Addendum No.2
to
CONSTRUCTION DOCUMENTS
for

June 2, 2025
2023159.00

NCISD New District Administration Building
21330 Valley Ranch Parkway
New Caney, TX. 77357
June 2, 2025

C4 ROOF TO WALL FLASHING @ ENTRANCE - B
3' = 1'-0"

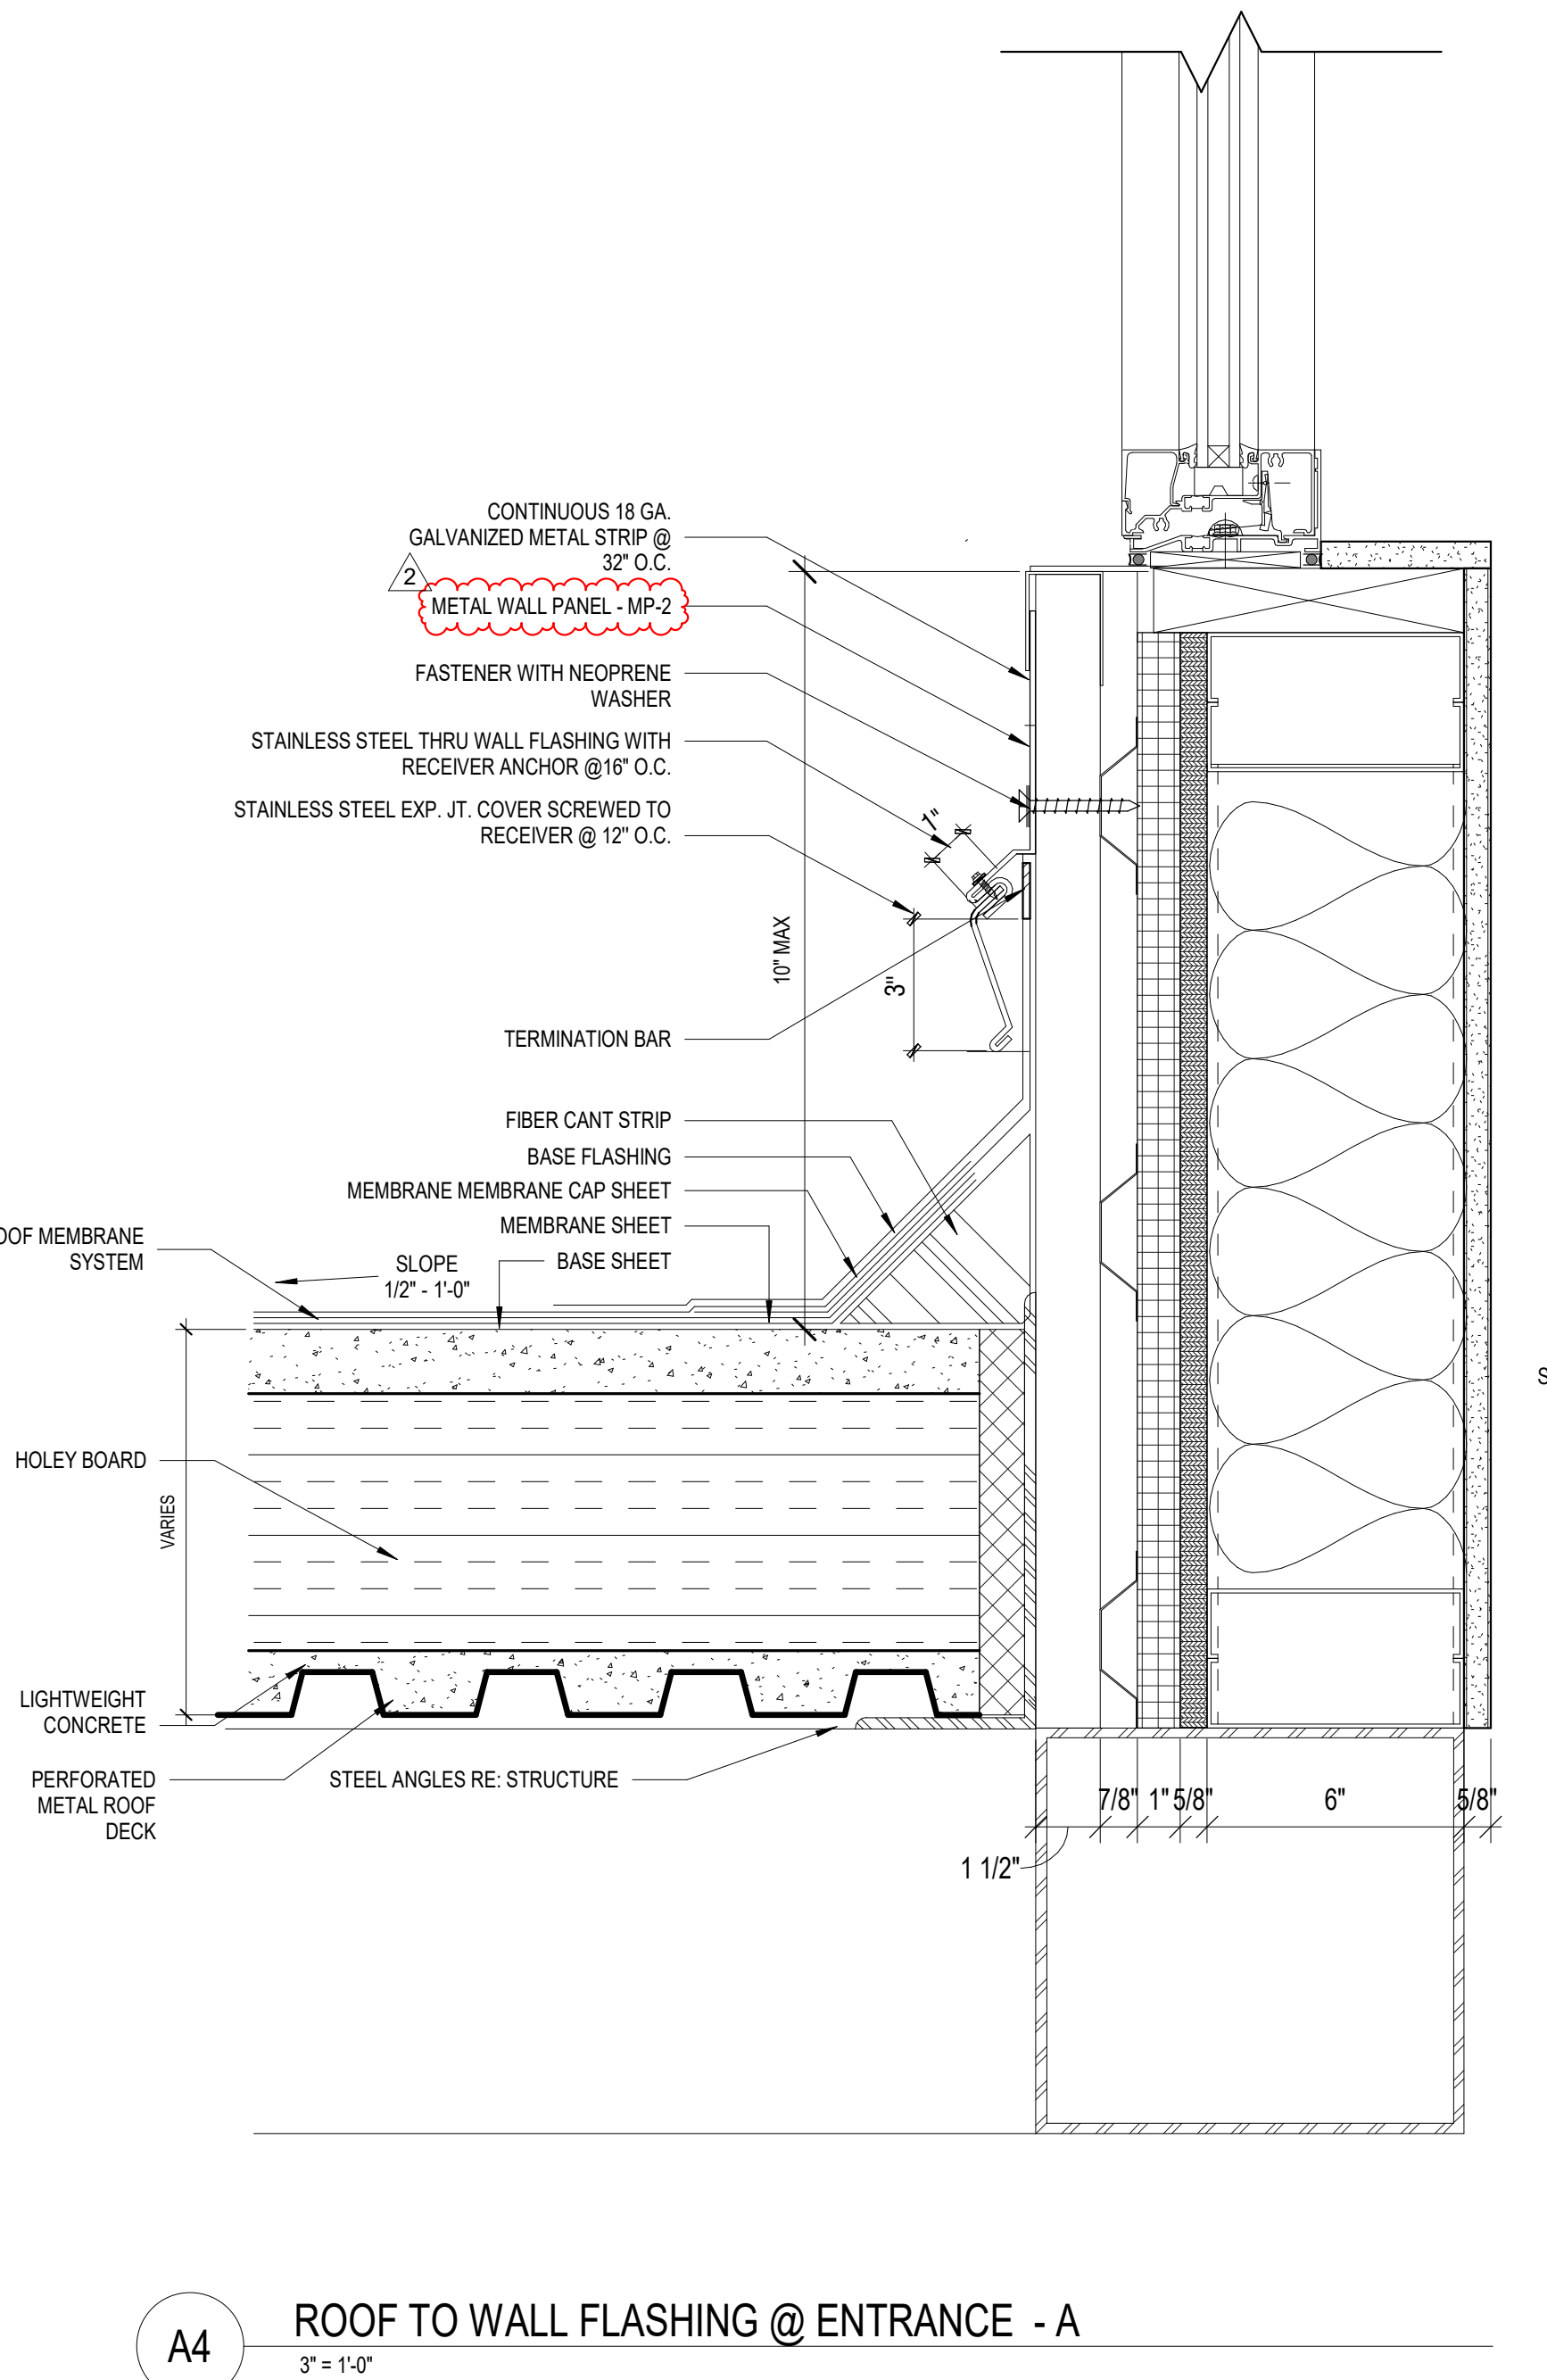
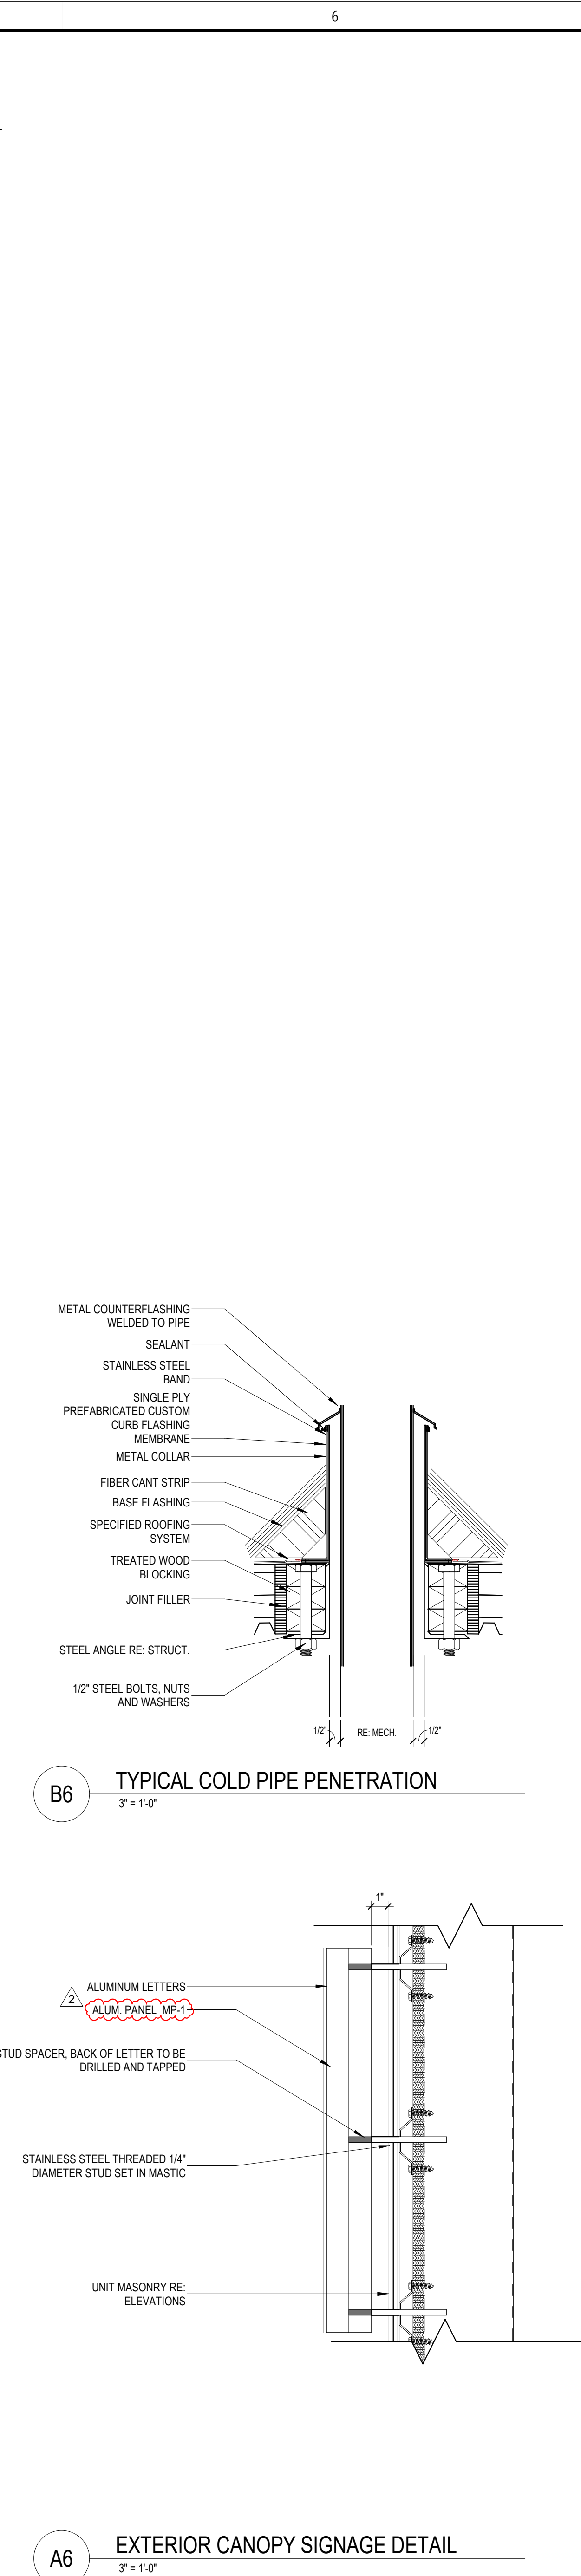
27. Sheet A-159 – Roof Details
- a. Refer to revised details A4, A6, and C4.
28. Sheet A-201 – Exterior Elevations
- a. Notes revised on all elevations.
 - b. Exterior finish schedule updated to show BRK-1 and BRK-2.

A-503

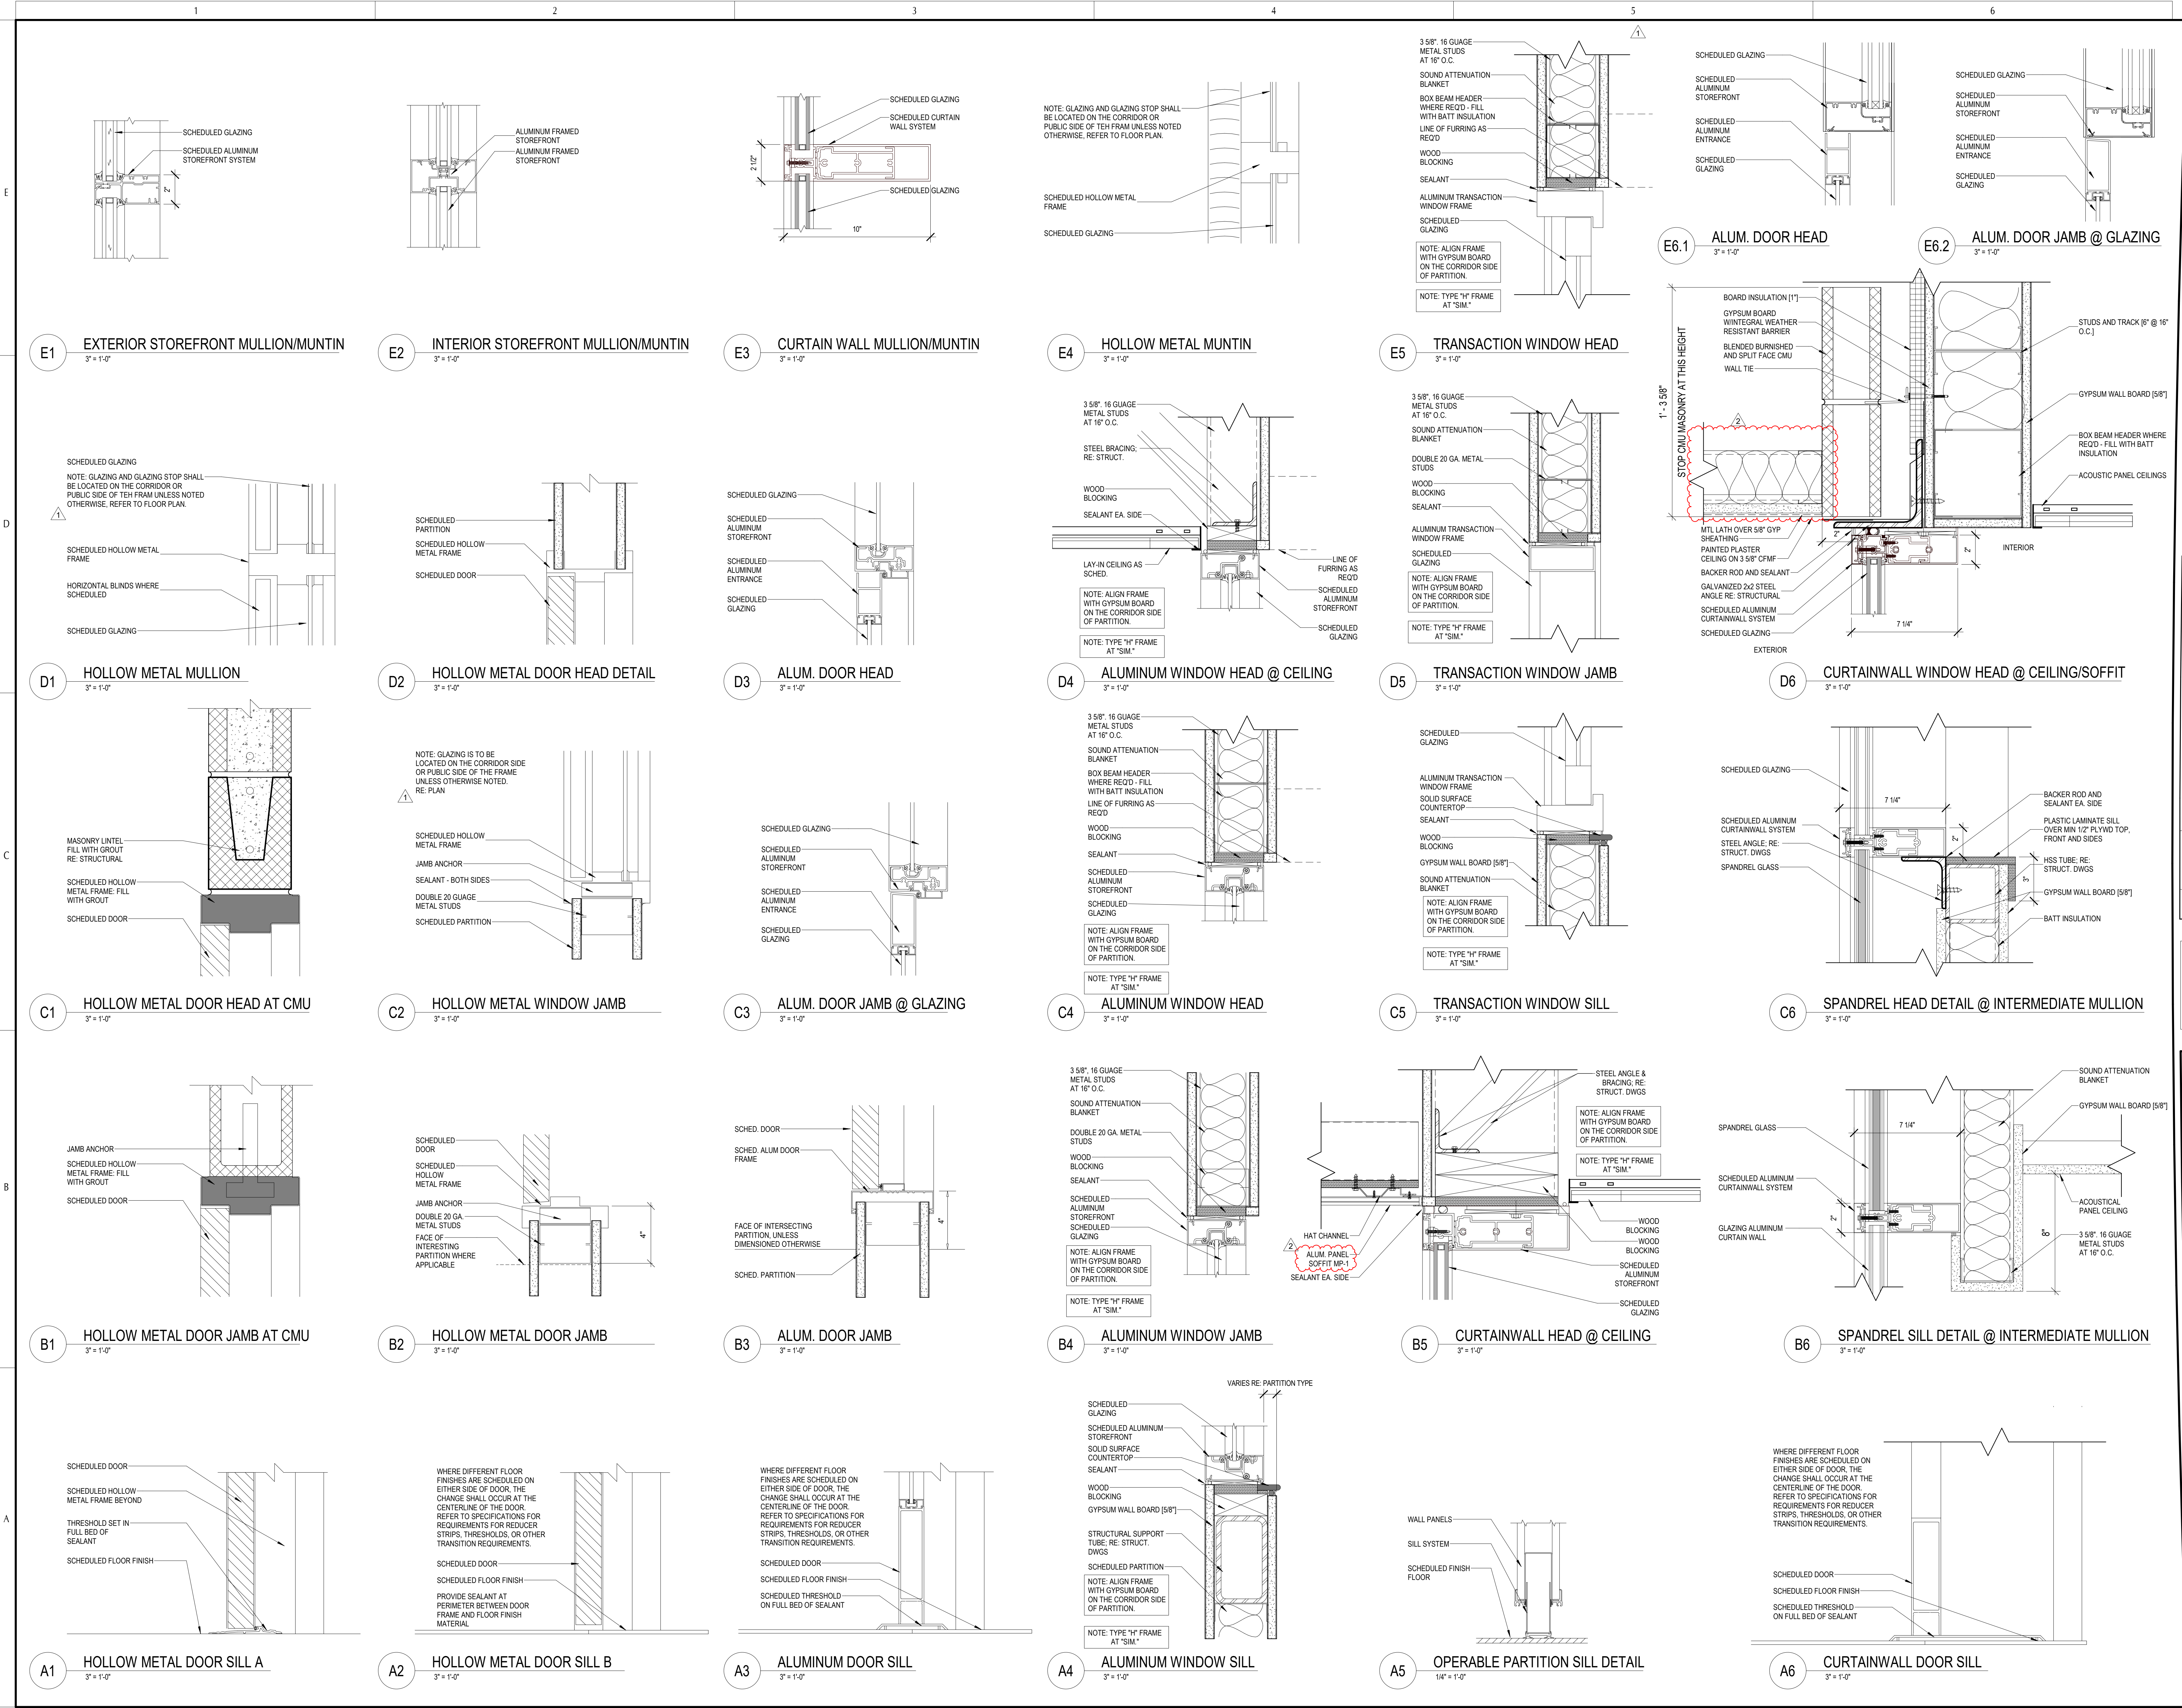
42. Sheet A-503 – Door and Window Details
- a. Refer to revised detail D1/A-503.
43. Sheet A-504 – Door and Window Details
- a. Revised plaster soffit ceiling structure to be painted plaster metal lath – 5/8" gypsum board sheathing, 3 5/8" metal studs on wall section detail D6/A-504.
